Report to Planning and Environment Committee

Subject: SOFCO Properties
3637 Colonel Talbot Road
File Number: Z-9664, Ward 9
Public Participation Meeting

Date: January 9, 2023

Conceptual Site Plan 3637 Colonel Talbot Road

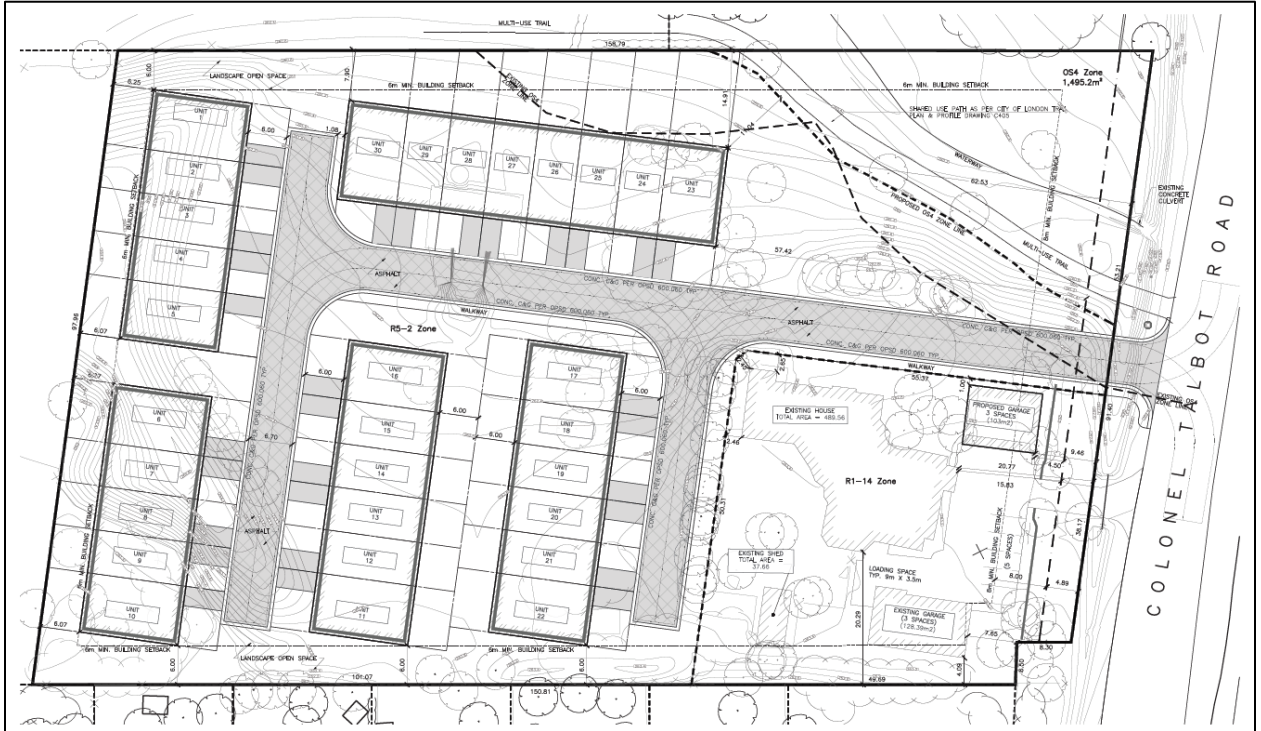
- Remove the proposed garage and parking spaces located in the front yard. Surface parking should be located behind the building, in the rear or interior side yard only [TLP Policy 272].

- Provide a walkway along the north-south drive aisle (in front of Units 1-10) [TLP Policy 255];
- Ensure the garages of the proposed townhouse units do not protrude beyond the front façade of the building and ensure they are less than 50% of the overall individual lot width [SWASP 20.5.3.9, iii, e];

- Orient and design Unit 1 and Unit 23 to include a similar level of architectural detail on the street and park-facing facades as is provided on the front elevation, including wrap around porches, front entrances, size and number of windows, materials, massing and any other relevant architectural detailing. [TLP Policy 291];

- As an R1 zone remove or relocate the proposed parking space along the front yard, Colonel Talbot Road (Zoning By-Law Z.1.-1 Section 4.19, 4), a).
- Remove or relocate the *proposed garage* to the interior side yard or rear yard. (Zoning By-Law Z.-1-Section 4, 4.1, 4).
